Title	IR KEYBOARD RECEIV
Size	B
Number	51-000-0008
Date:	13-Jul-1999
File:	C:\CLIENT\..\000-0008.SCH

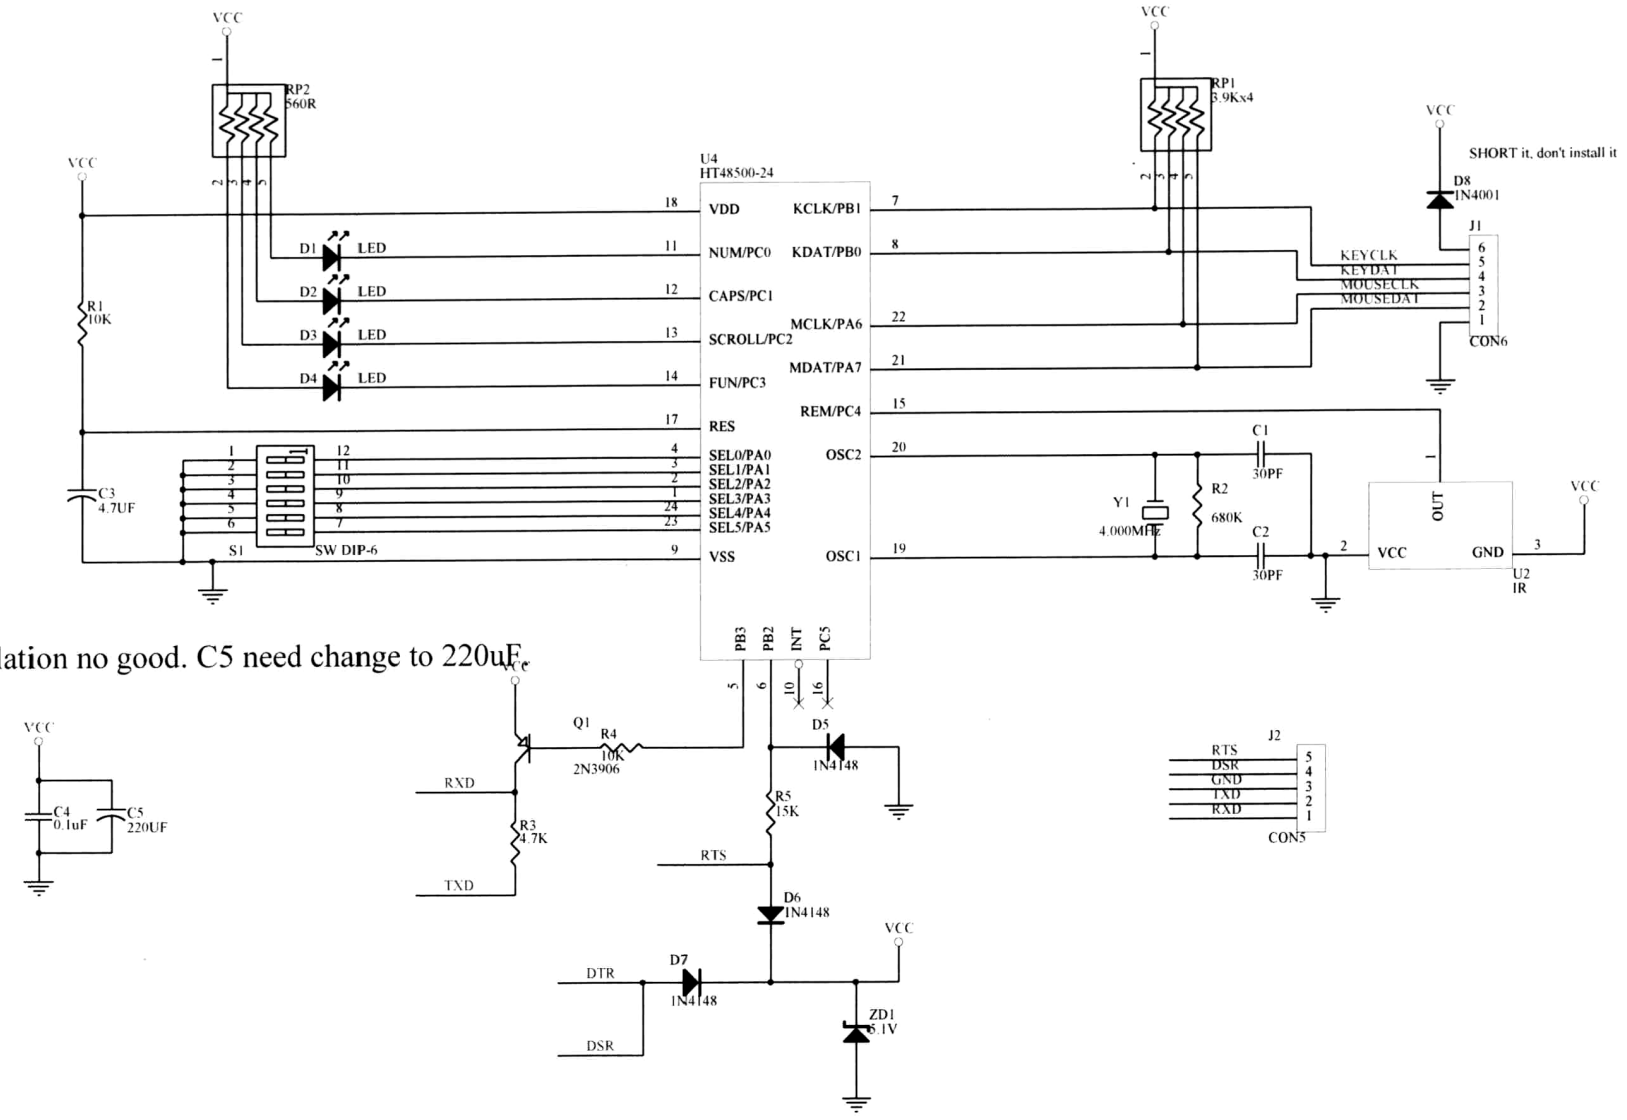
If power regulation no good. C5 need change to 220uF.
